Airworthiness Directive Schedule

Helicopters

Robinson R44 Series

19 December 2024

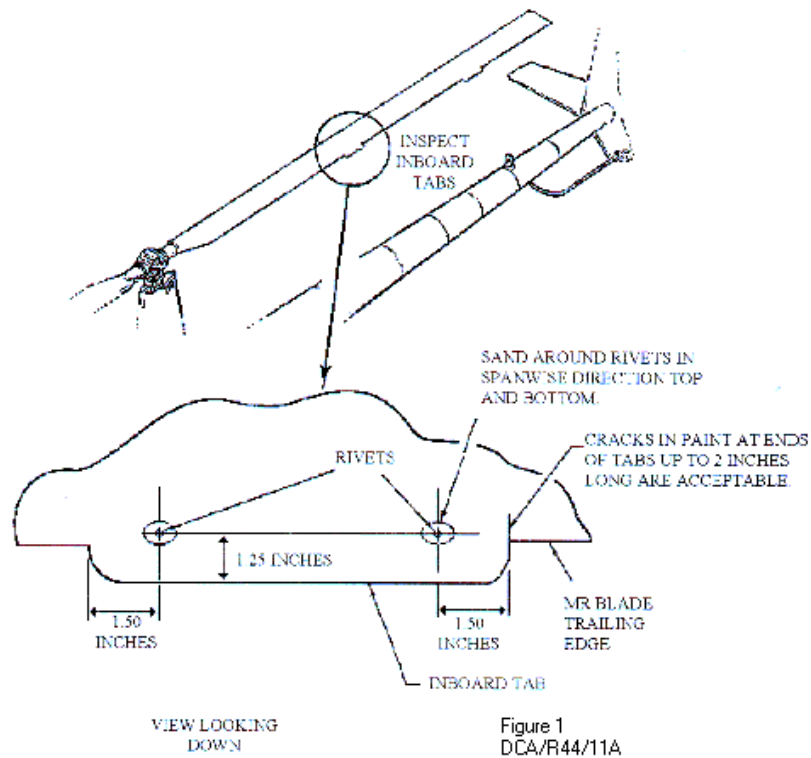
1. Perform a dye-penetrant inspection of the main rotor blade skin around both inboard trim tab alignment rivets as follows, referring to Figure 1.

a) Remove all paint around both rivets, exposing an area of approximately 3/4" in diameter, at the inboard trim tab on the top and bottom of each main rotor blade (4 places per main rotor blade). Use 180 grit or finer abrasive paper, followed by 600 grit or finer paper to eliminate coarse sanding marks. Sand only in a spanwise direction. Do not use chemical paint strippers.

b) Inspect the main rotor blade skin around the rivets on the upper and lower surfaces (4 locations) using a dye-penetrant inspection method.

2. Using a 5-power or higher magnifying glass, visually inspect both upper and lower main rotor blade skin surfaces around the inboard trim tab rivets (4 locations) for cracks. If a crack is found, replace the main rotor blade with an airworthy main rotor blade before further flight.

3. Install a set of main rotor blades, P/N C016-2. This constitutes terminating action for the inspections required by this AD.

FIGURE 1
AD 99-13-11

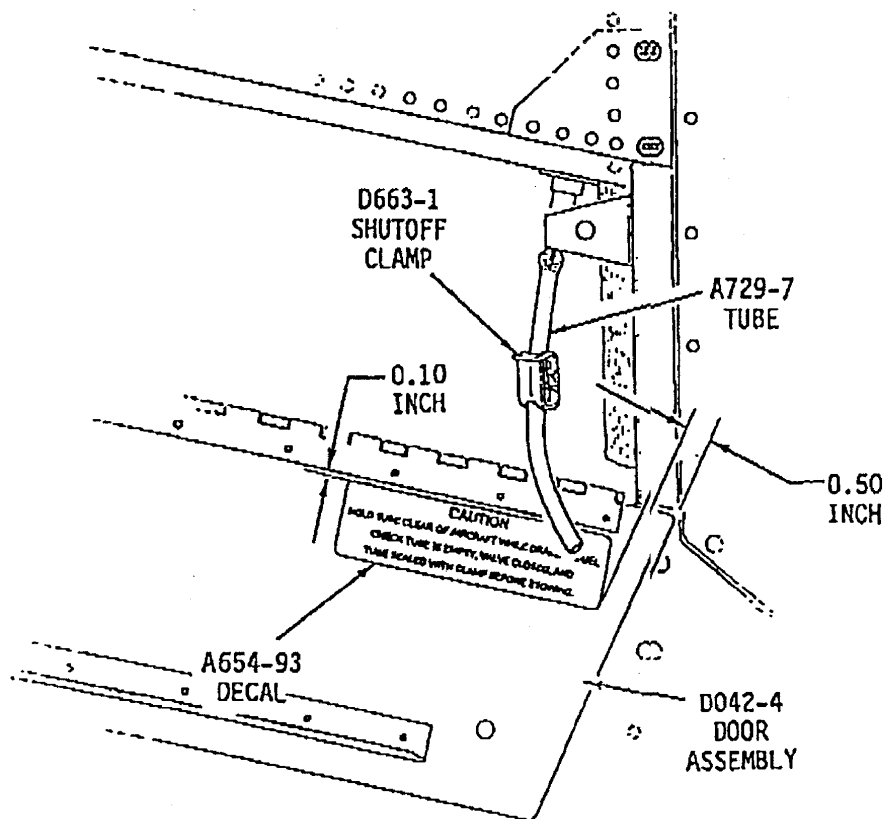
Install a shutoff clamp, P/N D663-1, by sliding it onto the auxiliary fuel tank sump drain tube, P/N A729-7, as shown.

Install placard decal, P/N A654-93, as shown.

Figure 1 – Section of MRB P/N C016-7 (View of blade lower surface)

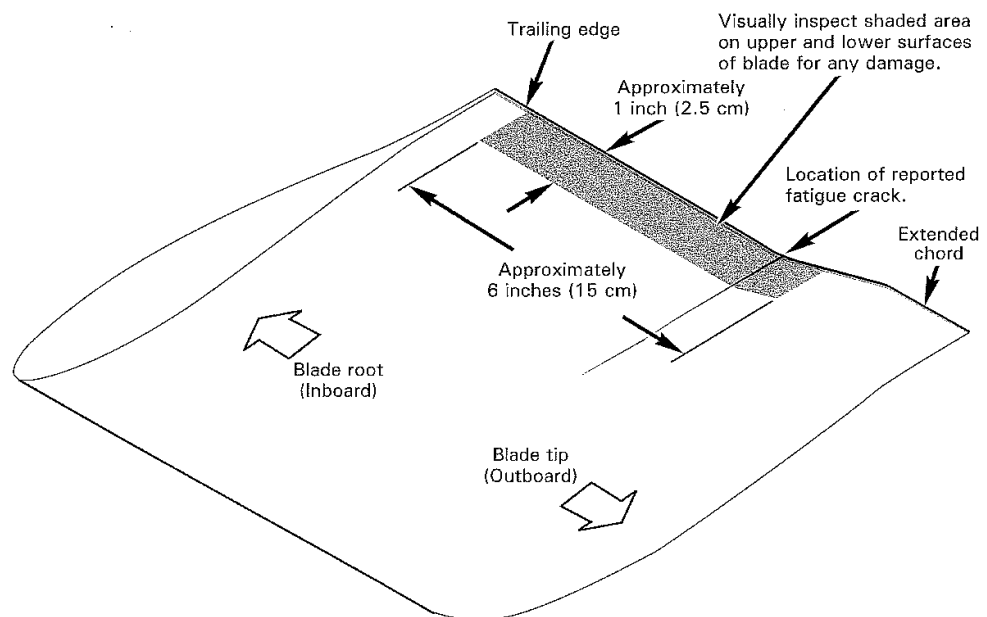
1. Inspect the upper and lower surfaces of each main rotor blade in the area shown in Figure 1. Inspect for any damage which may initiate a fatigue crack. A stepladder may be required to inspect the blades.

If the inspection reveals any damage or unusual marks, then the blades must be inspected by a maintenance engineer before further flight.

2. Modify the main rotor blades per the instructions in Robinson Helicopter Company R44 Service Bulletin SB-89 dated 30 March 2015.
